## **PECAN POINTE SUBDIVISION, PART B**

APPLICATION NUMBER 24 DATE August 16, 2007

REQUEST Subdivision

# DETAIL SITE PLAN

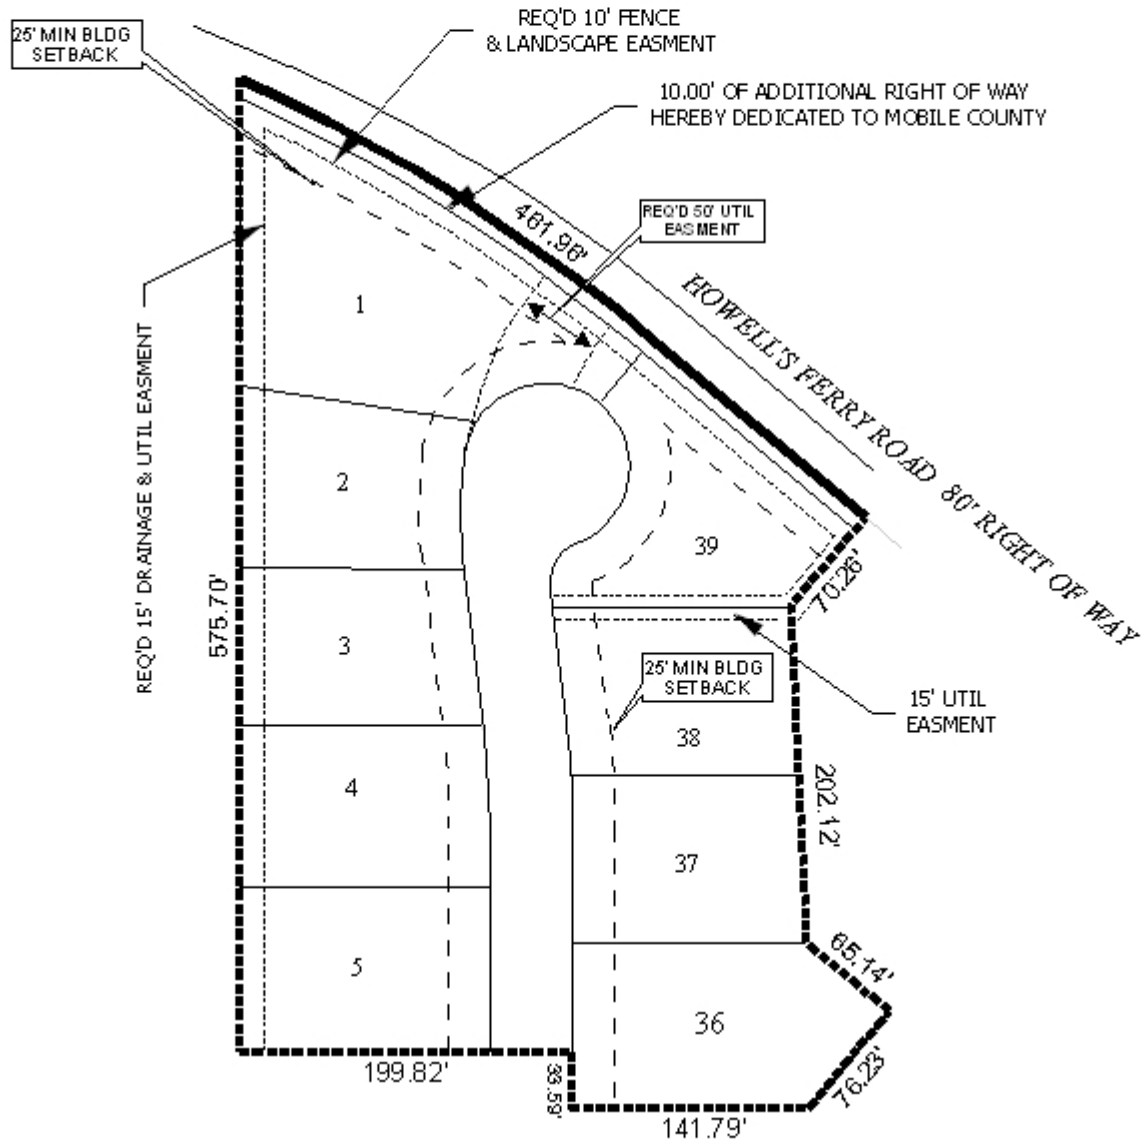
The site fronts Howell's Ferry Road, a planned major street with a right-of-way of 80-feet. As Howell's Ferry Road is a planned major street requiring a 100-foot right-of-way, the dedication of sufficient right-of-way to provide 50-feet from the centerline of Howell's Ferry Road should be required. As a means of access management, the placement of a note on the final plat stating that Lots 1 and 39 are denied direct access to Howell's Ferry Road, should be required. Additionally, any new road for the site is to be dedicated and constructed to meet County Engineering Standards, including the dedication of a sufficient radius at Howell's Ferry Road and the new street as determined by County Engineering.

The note illustrated on the preliminary plat stating "Required 10' Common Area Easement for fence and landscaping" should be revised to simply state "10-foot Fence and landscaping easement". However, if it is also intended as common area, the common area should not be shown as a part of lots 1 and 39.

- 3) the placement of a note on the final plat stating that Lots 1 and 39 are denied direct access to Howell's Ferry Road;
- 4) the **revision** of the "Required 10' Common Area easement for fence and landscaping" note;

- 7) the correction of the property description of the Final Plat.

- 1) dedication of sufficient right-of-way to provide a minimum of 50' from centerline of Howell's Ferry Road;
- 2) dedication and construction of new roads to meet County Engineering Standards;
